ADDENDUM No. 1
TO THE
CONTRACT DOCUMENTS FOR CONSTRUCTION OF
SUNSHINE PARK TRAILS EXPANSION
PROJECT # 20GR21

ISSUED THIS 16TH DAY OF JANUARY, 2026.

**SUNSHINE PARK TRAILS
EXPANSION**

**CONSTRUCTION
SITE PLAN**

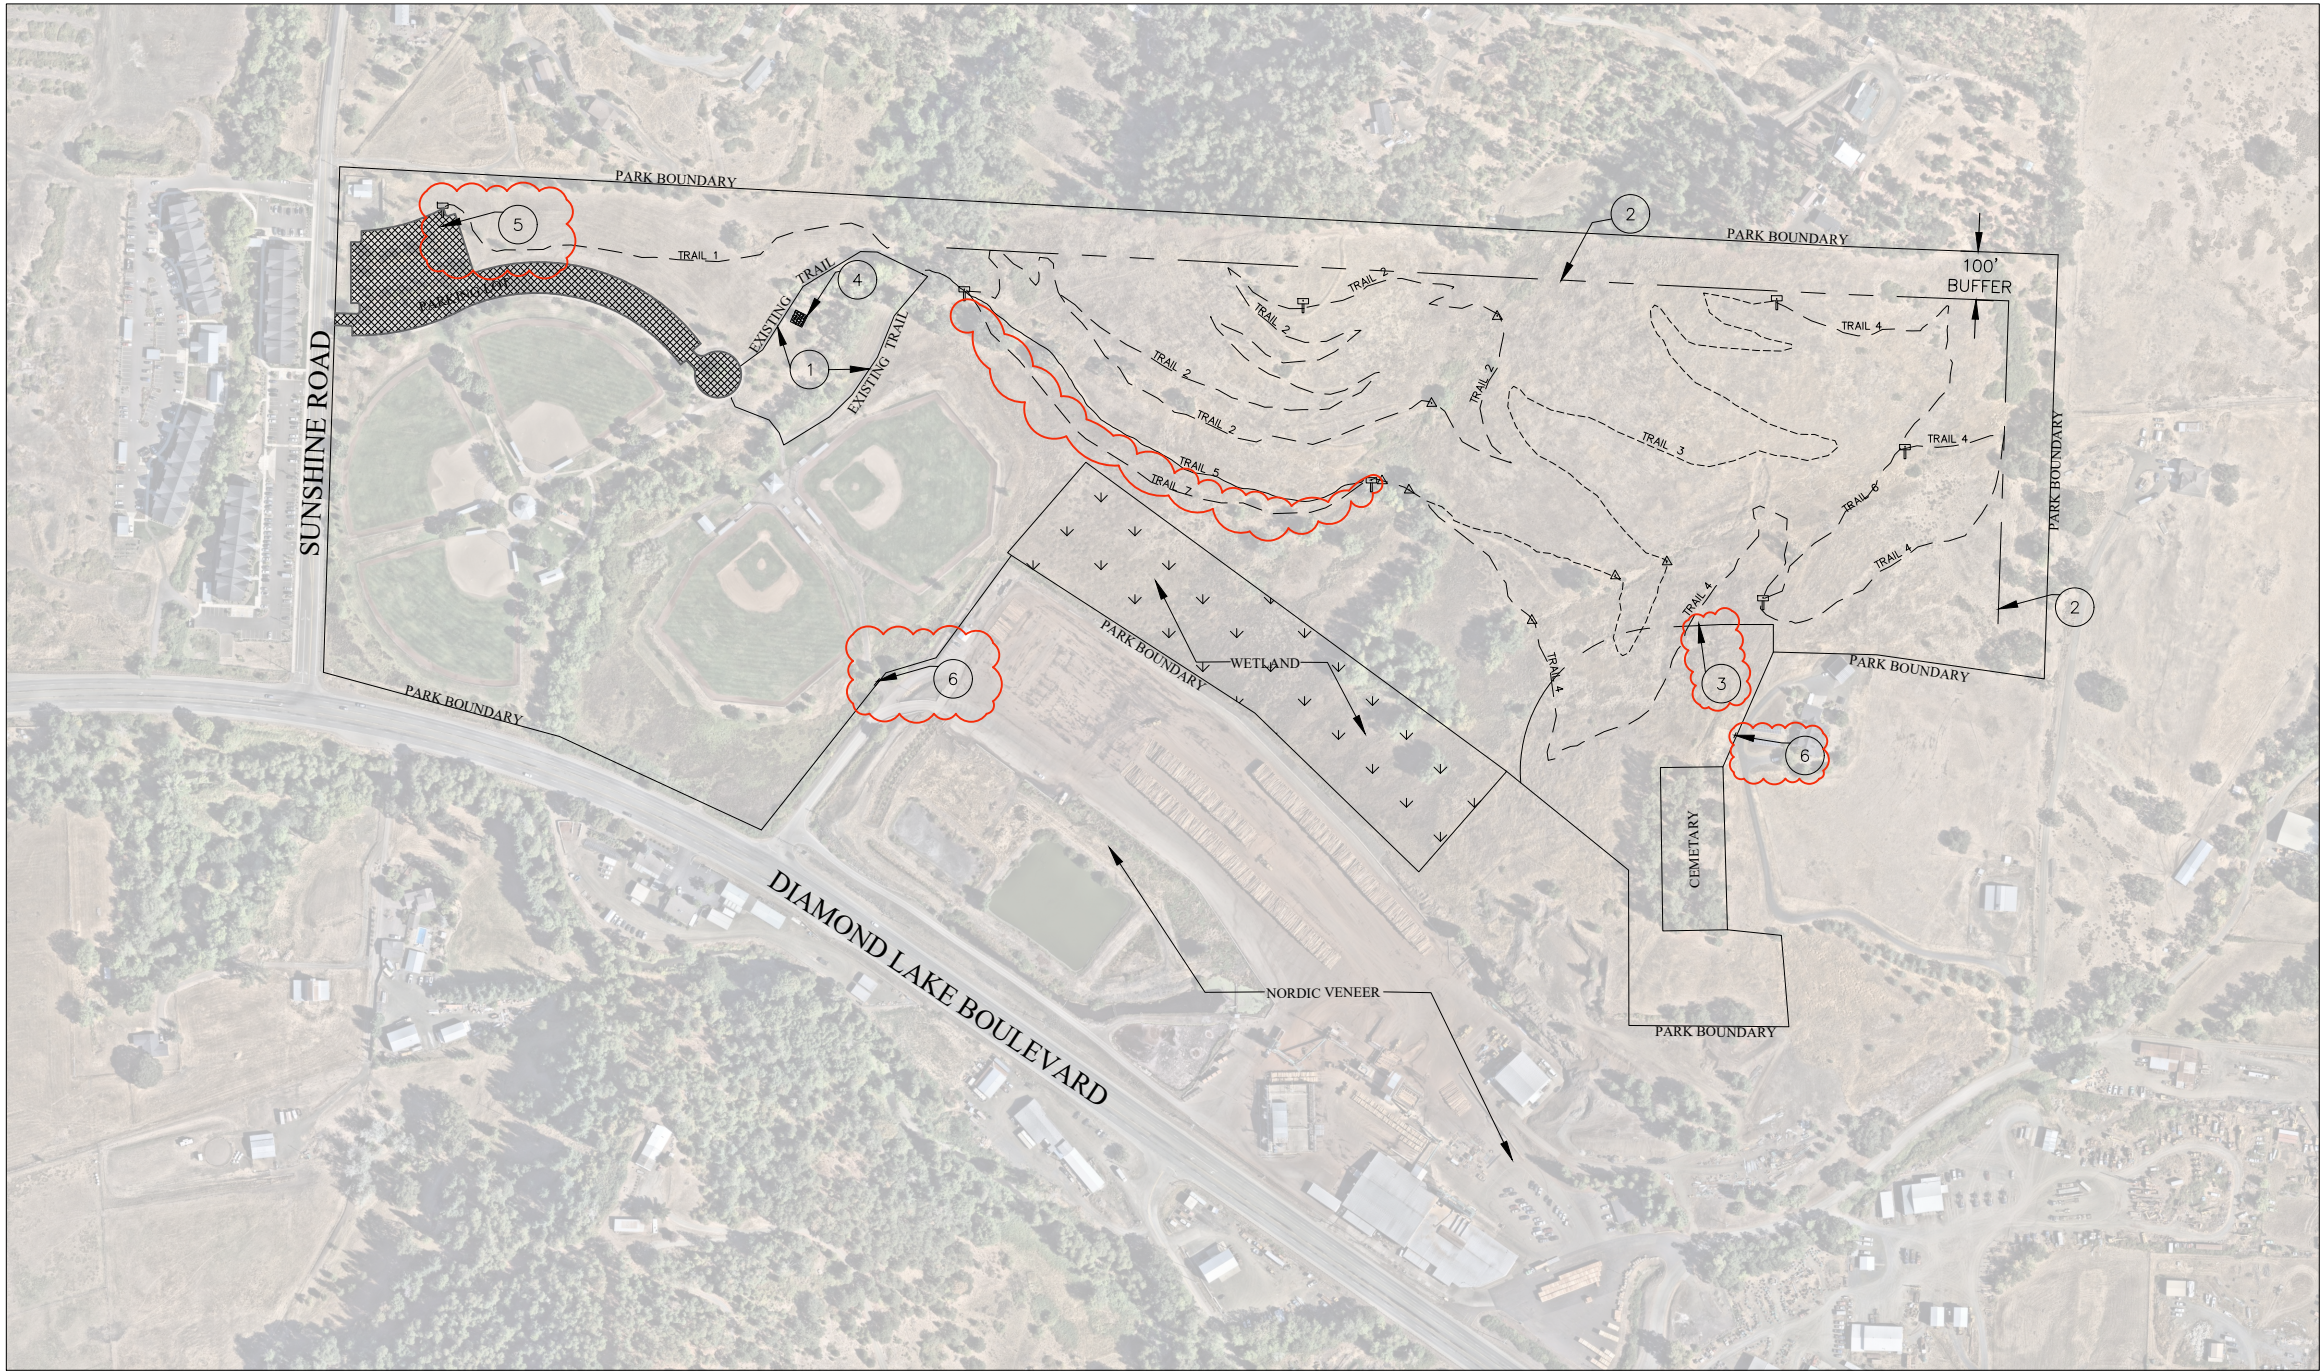
Sheet C1:

- **Changed** site note #3
- **Added** proposed staging area
- **Added** equipment access points
- **Changed** classification of trail 7 from universal access to beginner (class 2)

**SUNSHINE PARK TRAILS
EXPANSION**
**CONSTRUCTION
TOPOGRAPHY- WEST SIDE**

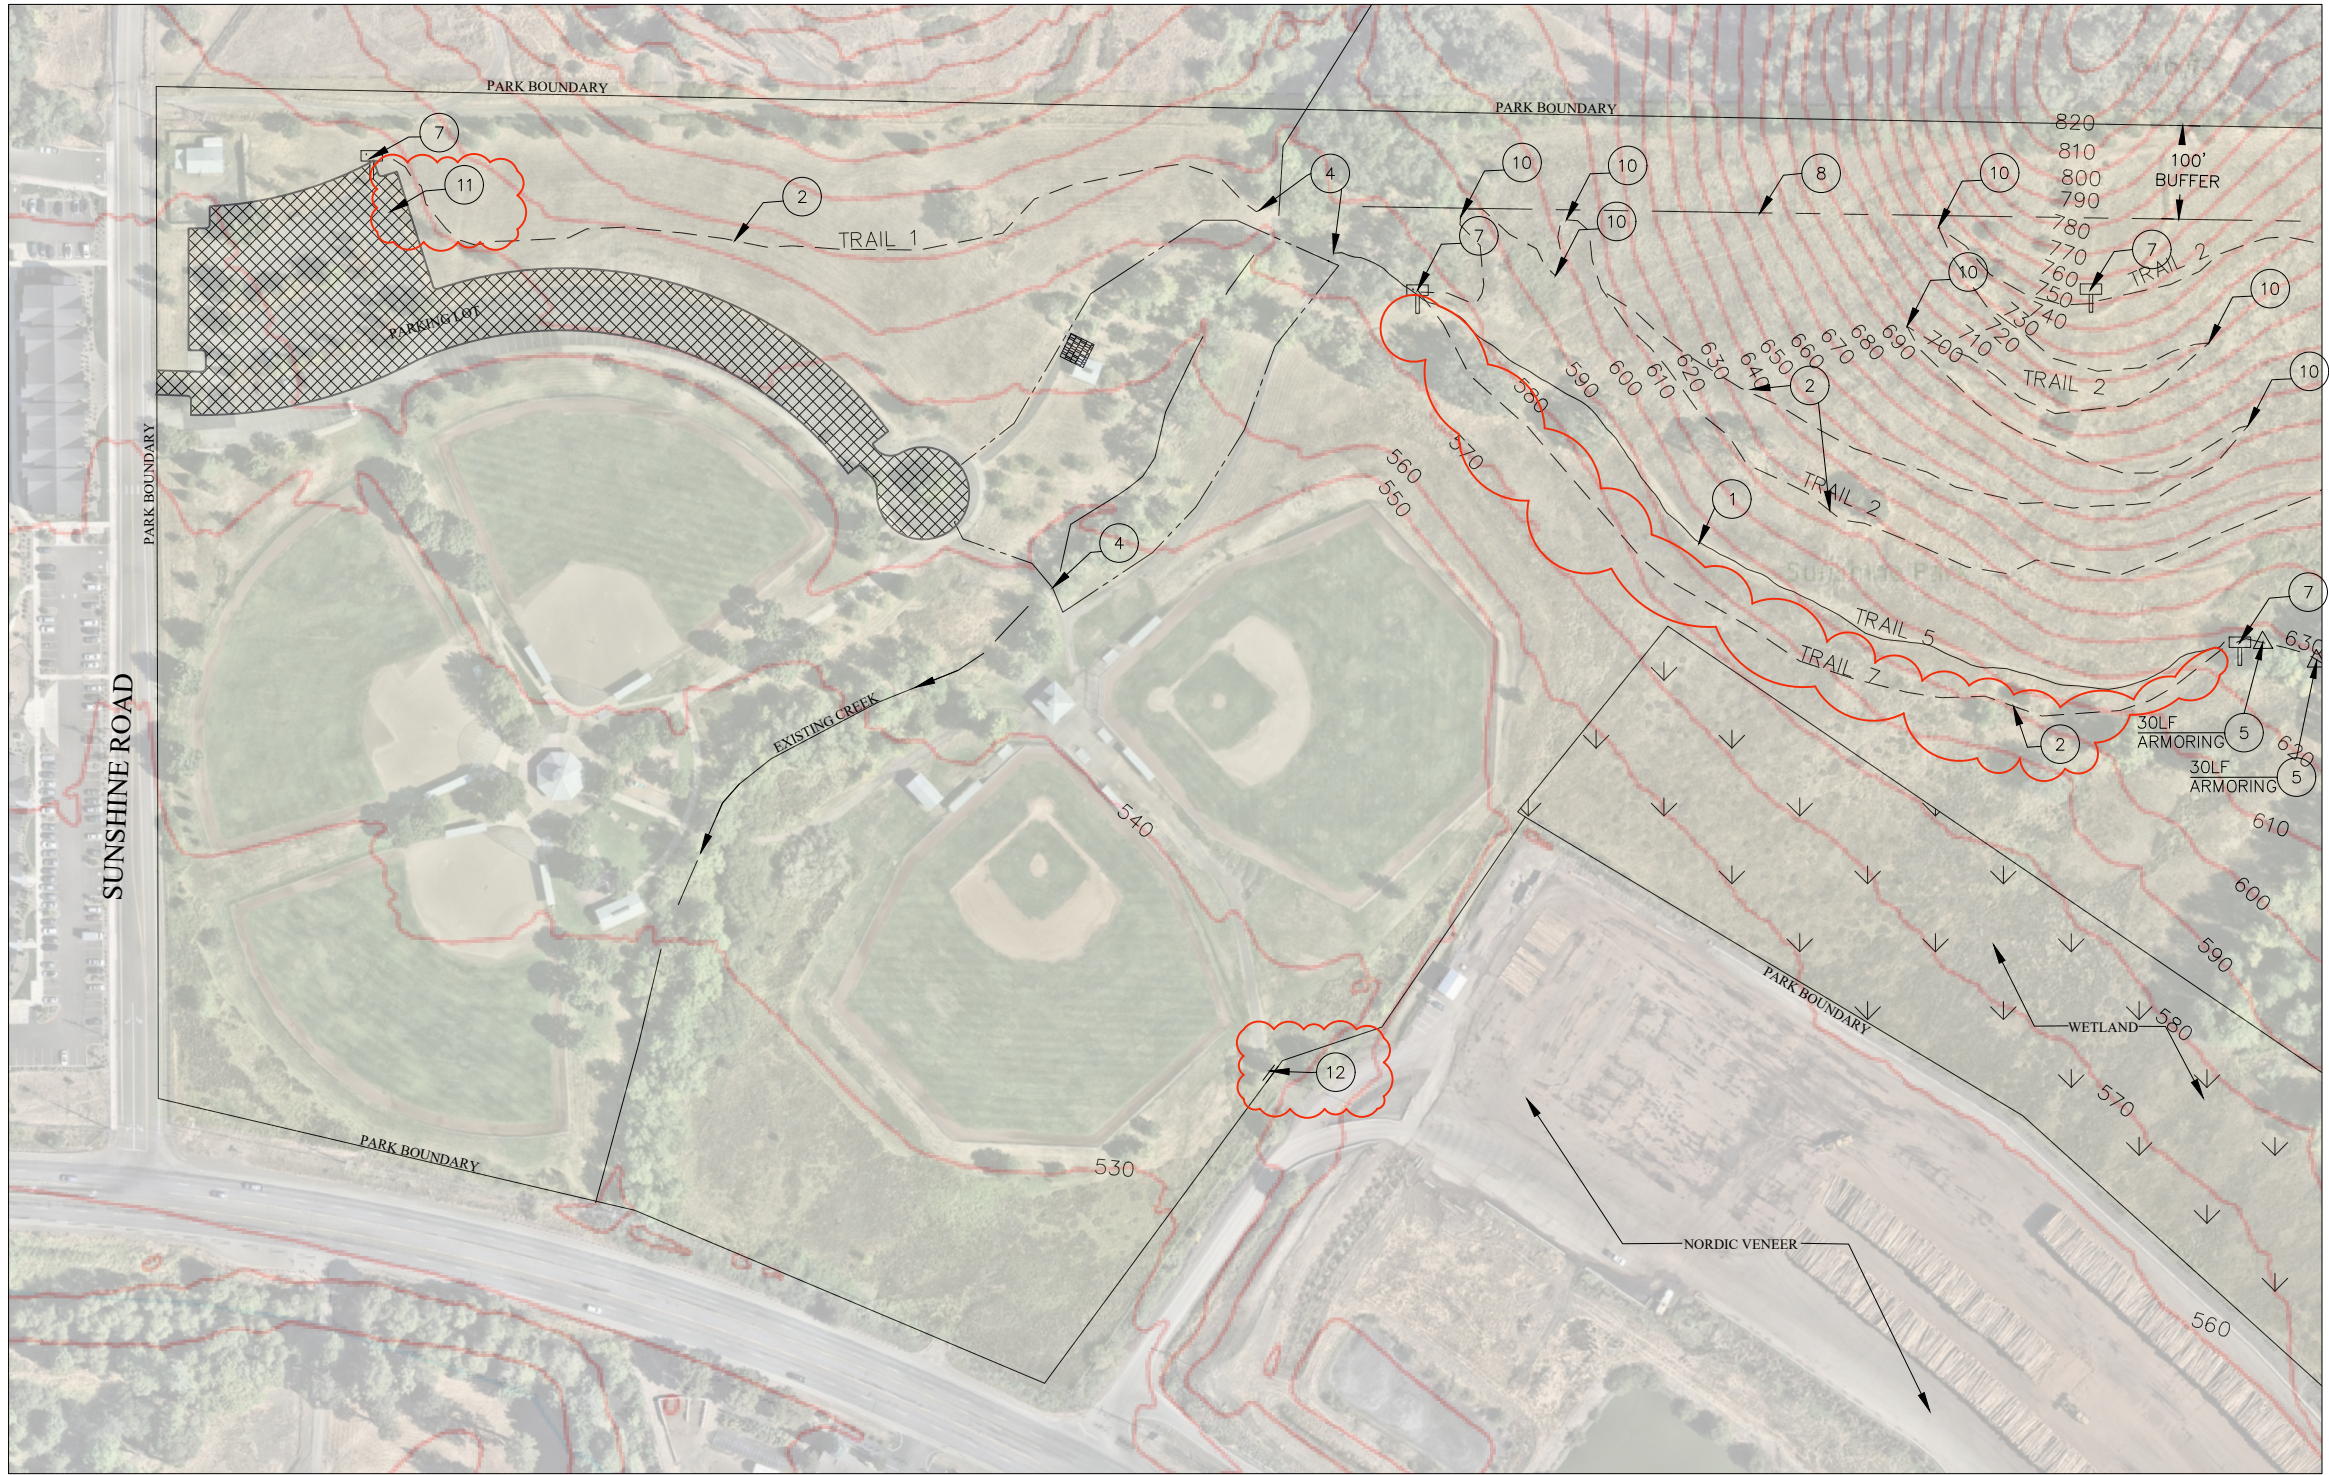
Sheet C2:

- **Added** proposed staging area
- **Added** equipment access point

- **Changed** classification of trail 7 from universal access to beginner (class 2)

SUNSHINE PARK TRAILS EXPANSION	PROJECT NO. 20GR21	DRAWING NO. C3
GENERAL TOPOGRAPHY - EAST SIDE	DATE JAN 2026	SHEET NO. 4 OF 6

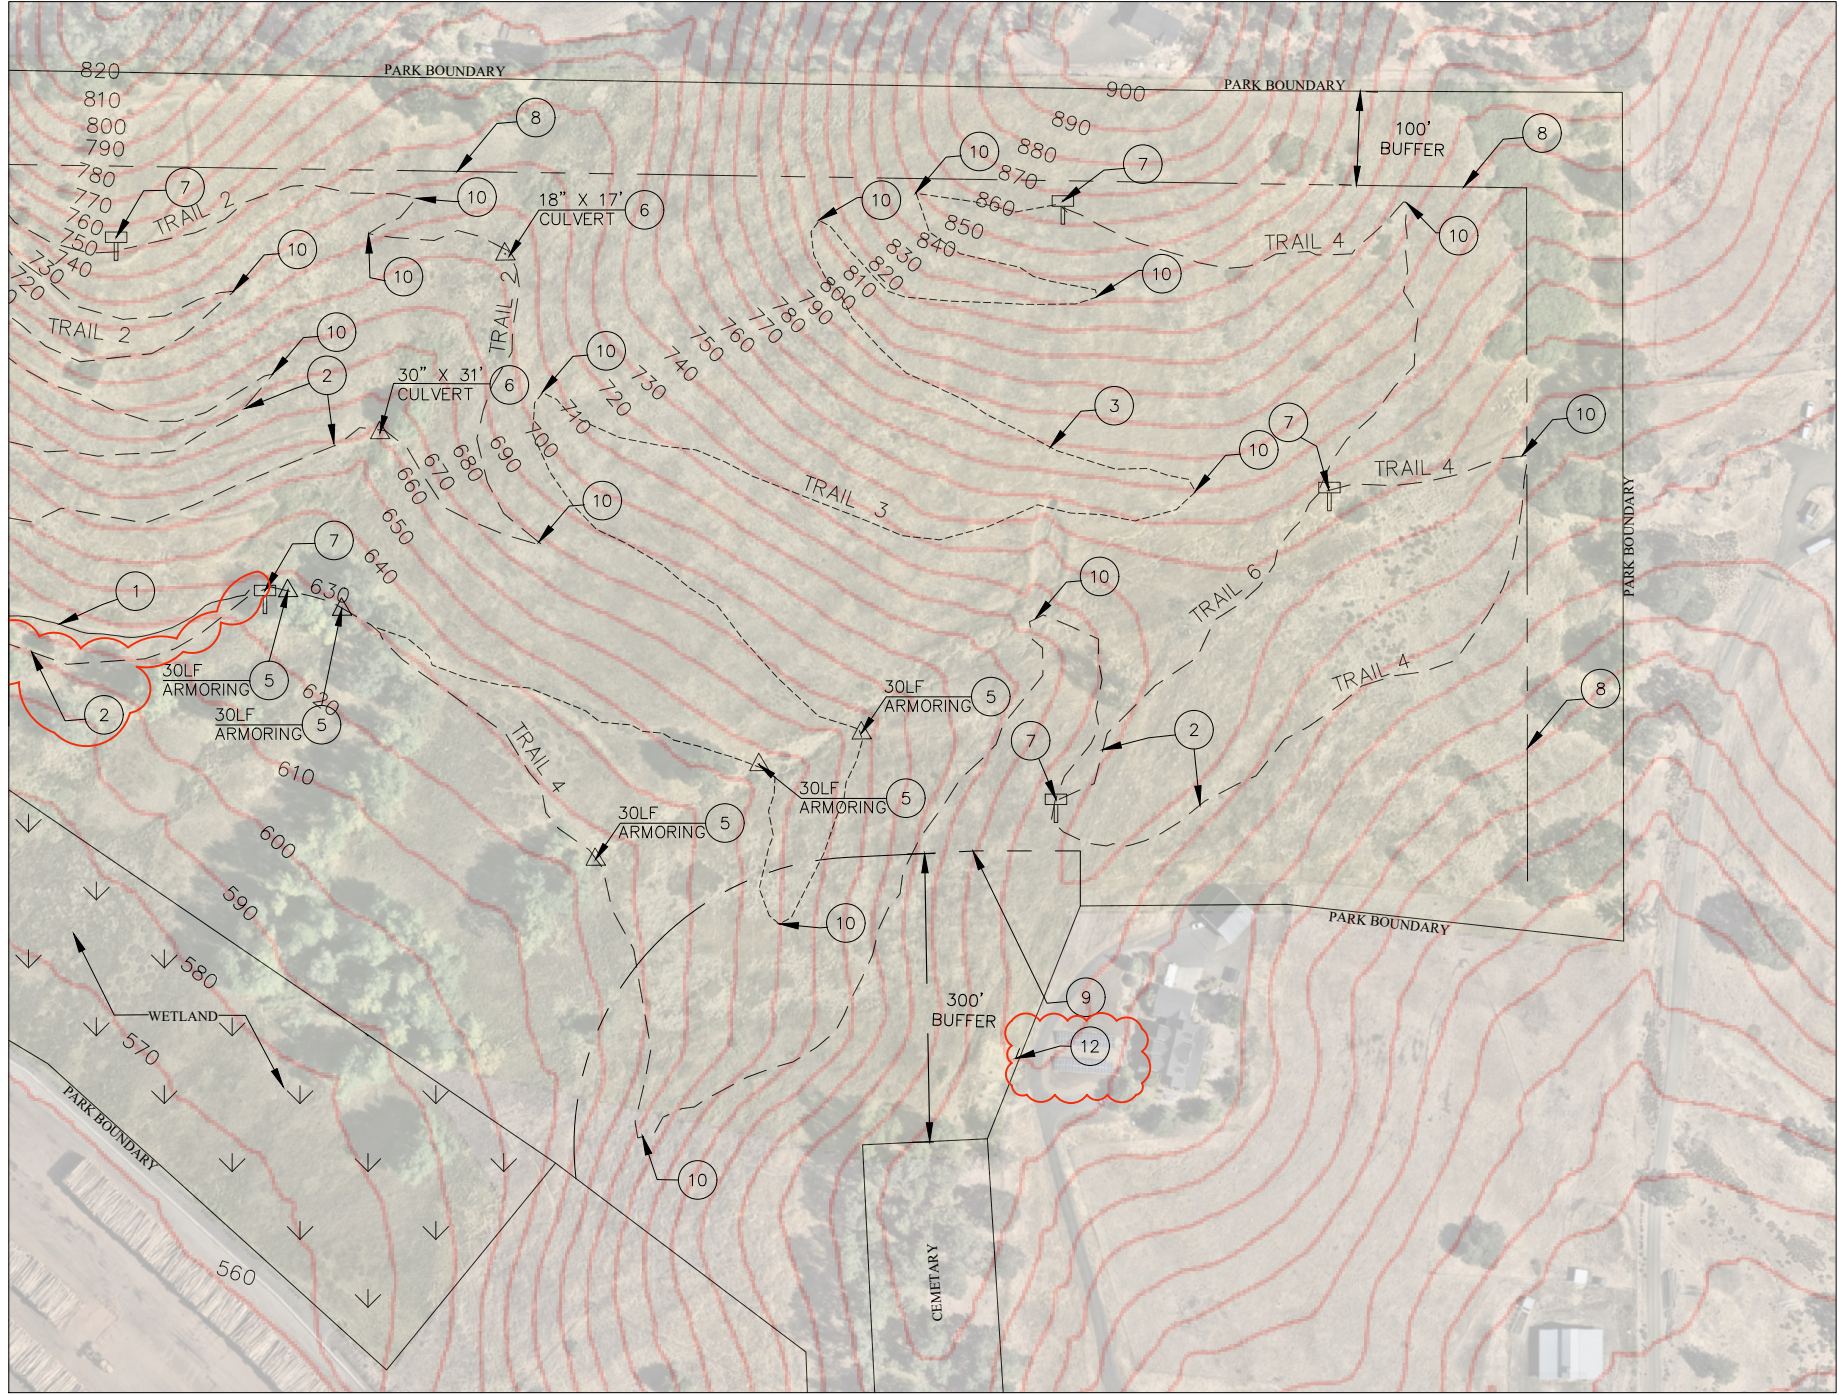
Sheet C3:

- **Changed** construction note #9
- **Added** equipment access point
- **Changed** classification of trail 7 from universal access to beginner (class 2)

IN-SLOPED TURN TYPICAL
SCALE: NTS

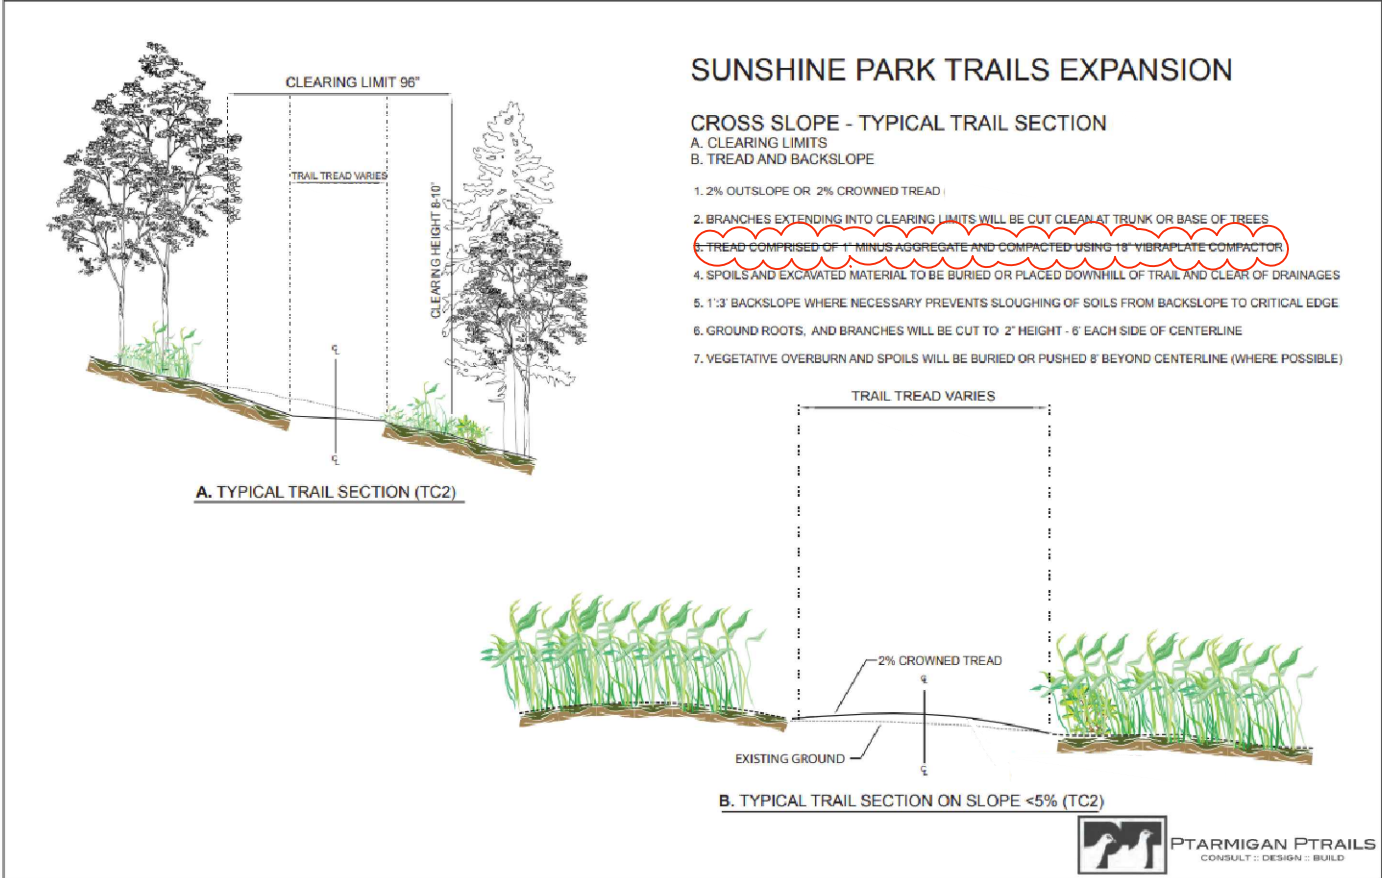
- **Removed** Seeding from Detail 1
- **Removed** Aggregate from Detail 2
- **Replaced** Table. See changes below:
 - Removed trail 7 from Universal Access.
 - Added trail 7 to beginner (class 2).
 - Changed Trail surfacing for Beginner (Class 2) and Blue Flow (Class 3) to be compacted native unless Schedule B – Alternate Bid is selected.
